#### **Addendum 128– UN Regulation No. 129**

#### **Revision 1 – Amendment 4**

Supplement 3 to the 01 series of amendments – Date of entry into force: 19 July 2018

#### **Uniform provisions concerning the approval of Enhanced Child Restraint Systems used on board of motor vehicles (ECRS)**

Figure 2

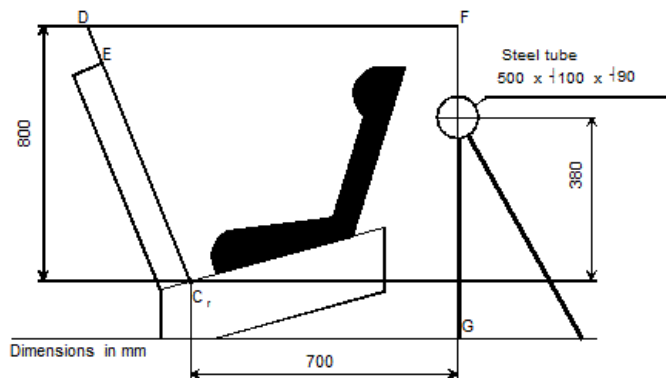
Paragraph 6.6.4.4.1.2.1, amend to read:

"6.6.4.4.1.2.1. Head excursion: no part of the head of the dummy shall pass beyond the planes FD, FG and DE, as shown in Figure 2 below. This shall be judged up to 300 ms or the moment that the dummy has come to a definitive standstill whatever occurs first.

Except when testing using Q6 dummy where:

The value in relation to the FD plane is 840 mm.

Where a test is conducted with paragraph 6.6.4.1.6.2. or paragraph 6.6.4.1.8.2. above, only the second configuration test results without 100 mm diameter bar will be considered.

### **Method of defining head impact area of devices with backrests or impact shields and for rearward-facing devices defining the minimum size of side wings**

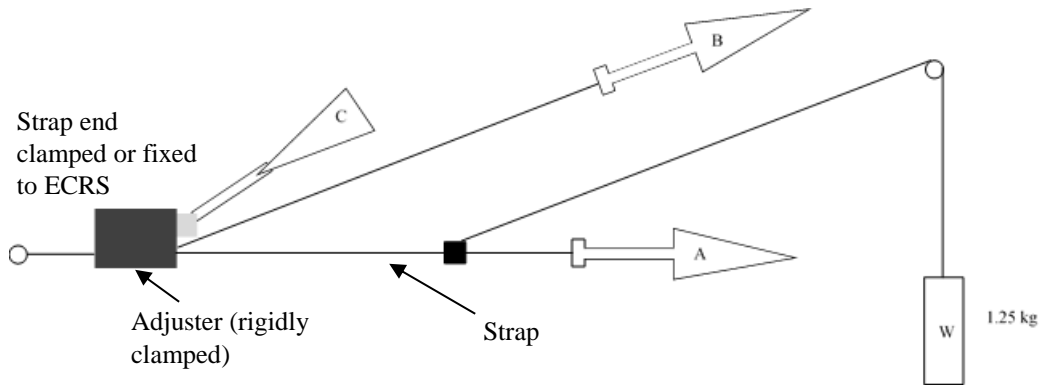
*Annex 14*, amend to read:

1. Head impact area
  - 1.1. Definition of backrest head impact area  
Place the device on the test bench described in...
  - 1.2. Definition of impact shield head impact area  
The impact shield head impact area is the whole upper surface of the impact shield, which comprises any surfaces visible from the top, looking down on the shield."

Figure 1

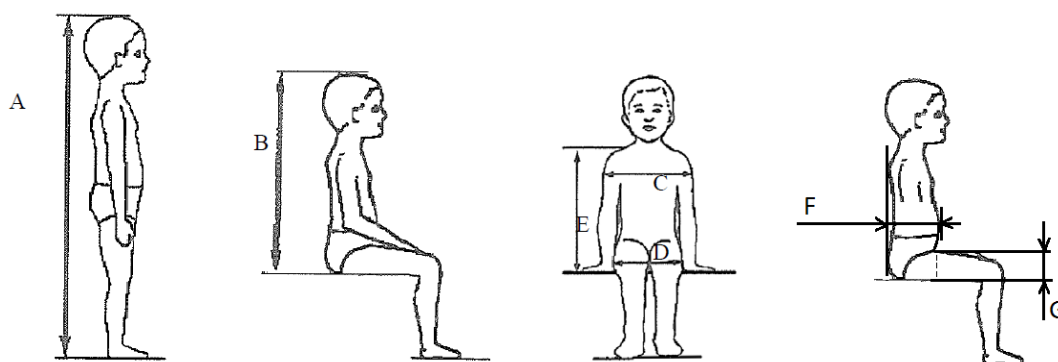
Annex 18, amend to read:

### Geometrical dimensions of Enhanced Child Restraint Systems

Figure 2  
ECRS Measurement Device - Side and Front View of the measuring device

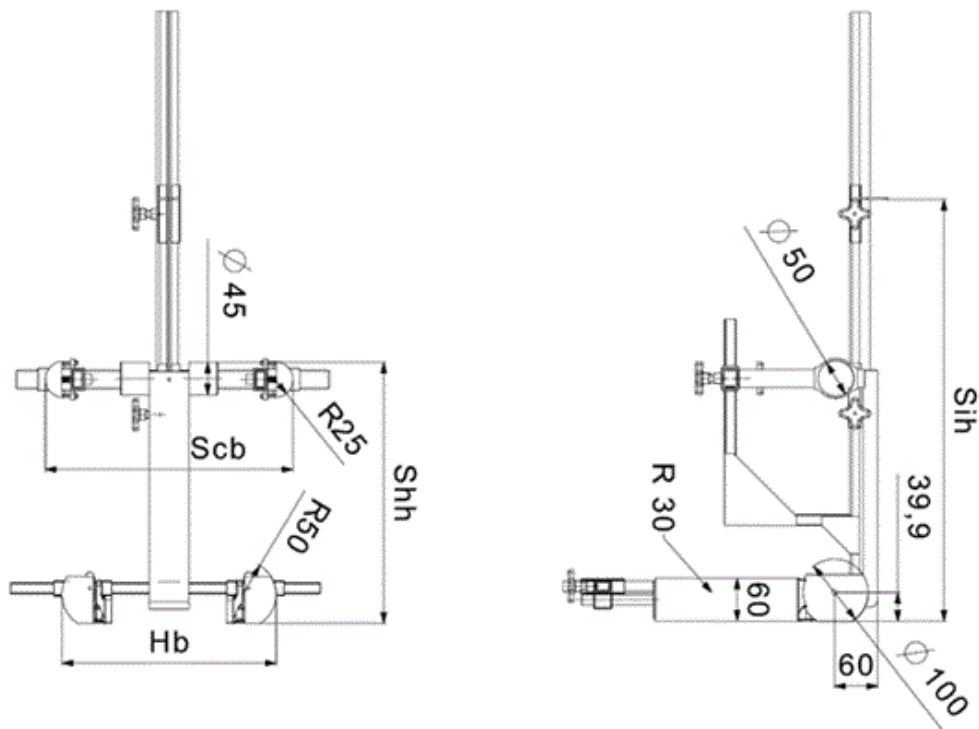
All lateral dimensions are measured under a contact force of 50 N with the devices described in Figure 2 and Figure 3 of this annex and the following tolerances will be applied:

The mass of the devices described in Figure 2 and Figure 3 of this annex shall be 10 kg  $\pm 1$  kg

For integral or non-integral ECRS the device shown in Annex 18, Figure 2 shall be used.

Figure 3  
**Side and Front View of the measuring device for measurements applicable to Enhanced Child Restraint Systems that feature an impact shield**

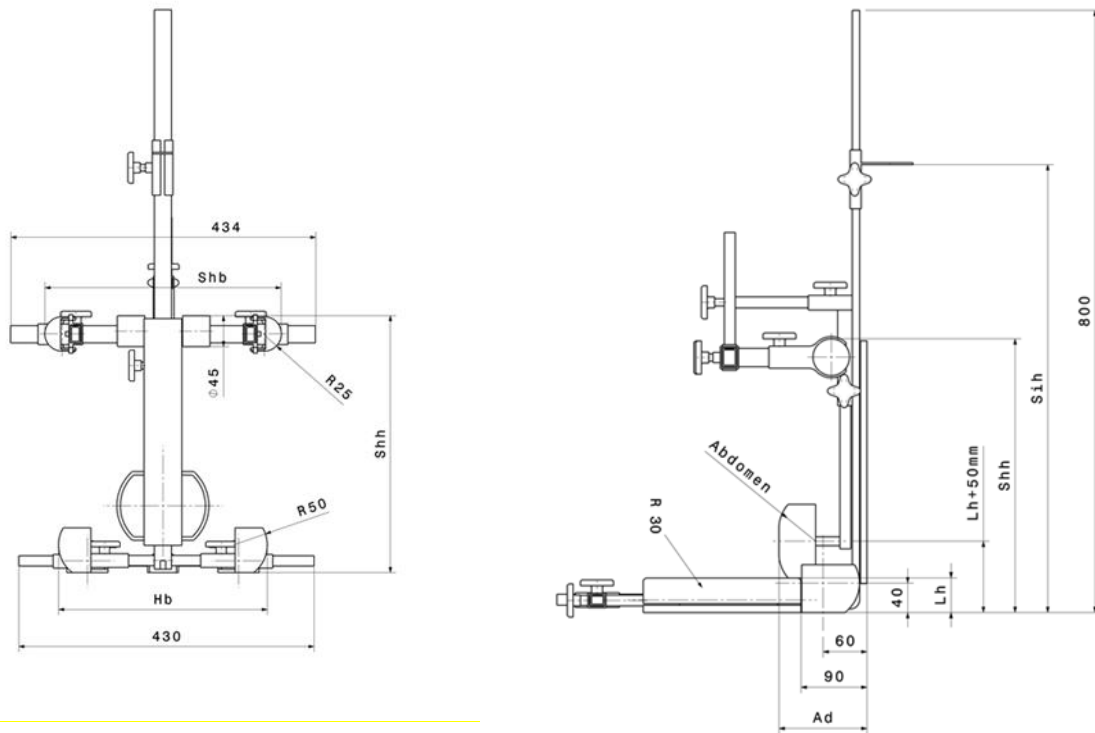
For ECRS with an impact shield the device shown in Annex 18, Figure 3 shall be used.
